RE: EROSION PROTECTION DESIGN CONCERNS IDENTIFIED AT RECENT SITE
VISIT (TAC NO. L52459) - *Docket 40-8907*

On behalf of United Nuclear Corporation (UNC) enclosed is the engineering evaluation and proposed reclamation alternatives for the areas of concern identified at the Church Rock Mine Tailings Impoundment in the memorandum from the NRC dated January 7, 2003.

**EROSION AND SEDIMENTATION EVALUATION AT THE
UNITED NUCLEAR CORPORATION
CHURCH ROCK URANIUM MILL TAILING SITE**

Photo 6 Minor Rilling on the East Sideslope of the Berm/access Road

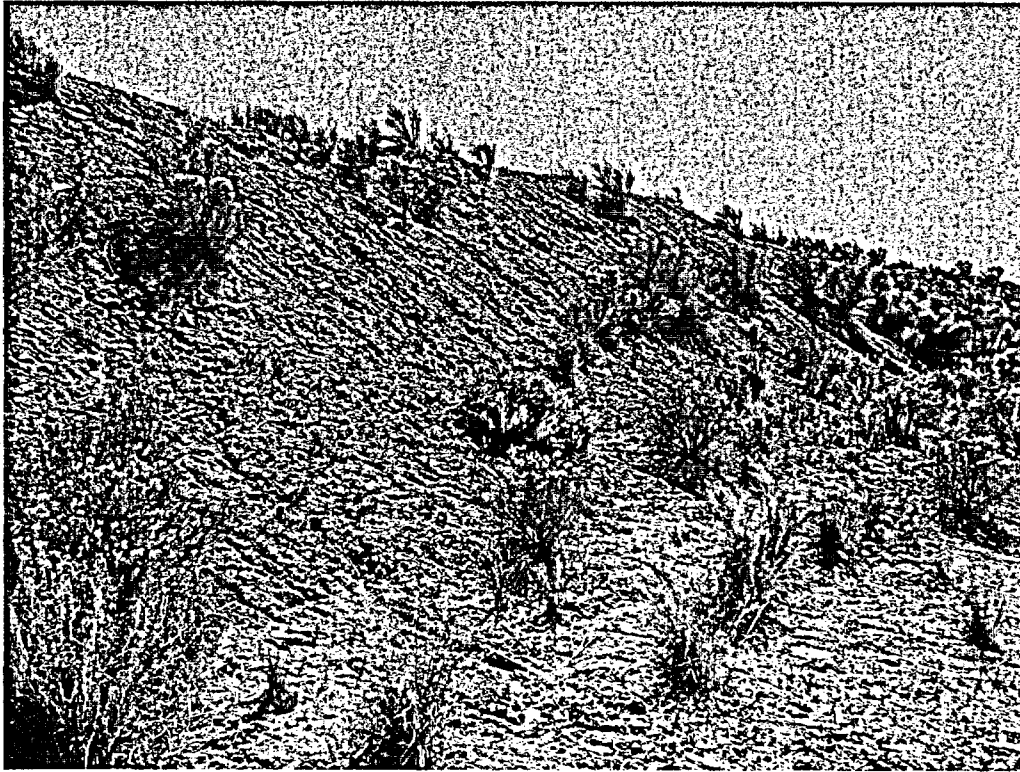
Erosion on the berm is limited to minor rilling on both the east and west embankments, with only a few areas of localized minor headcutting occurring where runoff from the road becomes concentrated. Rilling on the berm sideslope is shown on Photo 6. A cross section was surveyed in approximately the center of the berm to measure the existing embankment slopes, top width and height of the berm above the existing ground to the east and west. The berm sideslopes were measured to be approximately 1.6H:1V and 1.5H:1V on the east and west sides, respectively, and the top width was measured to be approximately 38 feet. The berm cross section is shown on Figure 3.

Placement of riprap on the east and west embankments of the access road will stop the minor rilling and headcutting that is currently occurring and will prevent future erosion. The minimum required D_{50} of the riprap is 1.2 inches, and it should be placed in a layer thickness of at least 3 inches. If larger riprap is used, it should be placed with a thickness of at least two times the D_{50} . Any riprap that is placed should be keyed into the toe of the slope a minimum of 3 feet to prevent scour at the toe and undercutting of the riprap. The extent and details of riprap placement are shown on Figure 4. Riprap used on the embankments will be sized to meet the gradation specifications shown in Table 4.

Photo 7 Eroded Riprap at the Western end of the Jetty

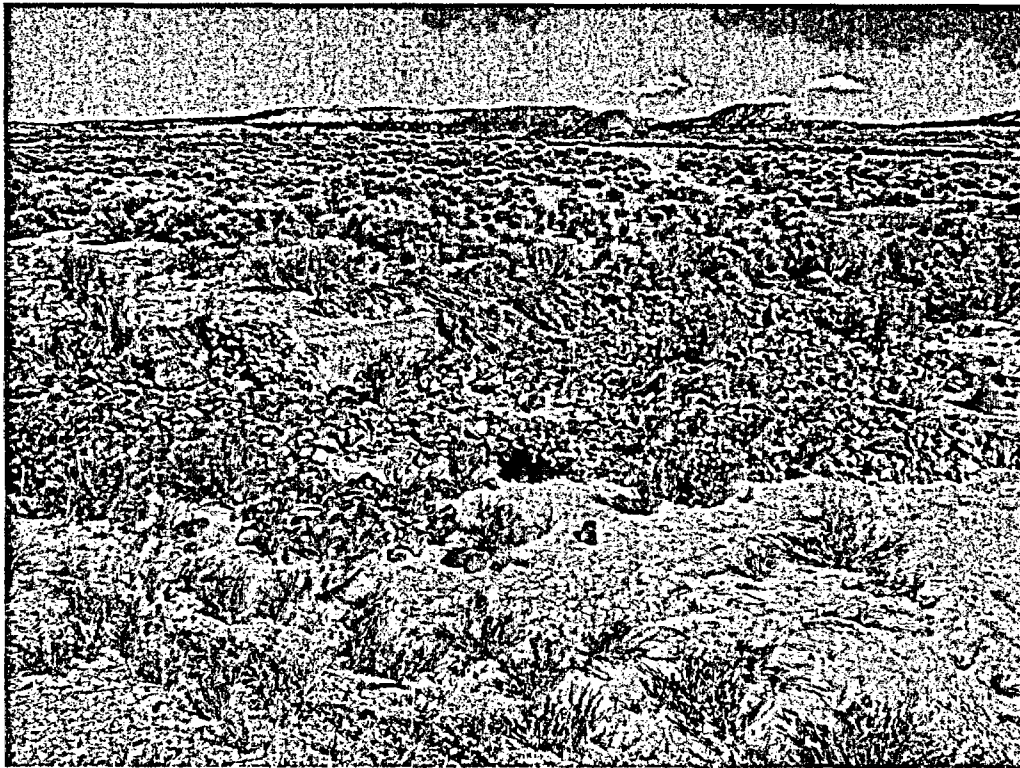
The displaced riprap on the jetty was inspected to determine the extent of the current damage caused by recent storms. The majority of the jetty is performing as designed, and damage to the riprap is confined to an area approximately 20 to 30 feet in length on the western end as shown in Photo 7.

The jetty was designed and constructed for runoff to flow over a width of at least 200 feet. In the area where the riprap has been eroded there is evidence that flows over the rock are highly concentrated into small flow paths caused by the establishment of small shrubs and vegetation upstream of the jetty. As seen in Photo 7, this concentration is causing the flow depths and velocities from storms smaller than the design storm to exceed the design flow depth and velocity in localized areas, mobilizing the riprap.

The overall damage to the jetty is minor, and MWH believes that it would be cost-effective to bond for annual repairs to the jetty, Option 3 above. During the field visit it was estimated that less than 10 cubic yards of riprap has become mobilized since reclamation was completed in 1996, and nearly all of the mobilized riprap has remained in the immediate vicinity of the jetty and could easily be placed back on the jetty. Therefore, the costs for ongoing repairing the riprap would be low. An additional cost-effective option that could be considered would be to remove the existing vegetation and bond for the cost of herbicides to be applied to prevent vegetation from becoming established in the future. Bonding calculations for annual monitoring and repair of the rock jetty and herbicide for control of vegetation upstream of the Jetty to prevent concentrated flow are presented in Appendix C with a net present value of \$140,550.
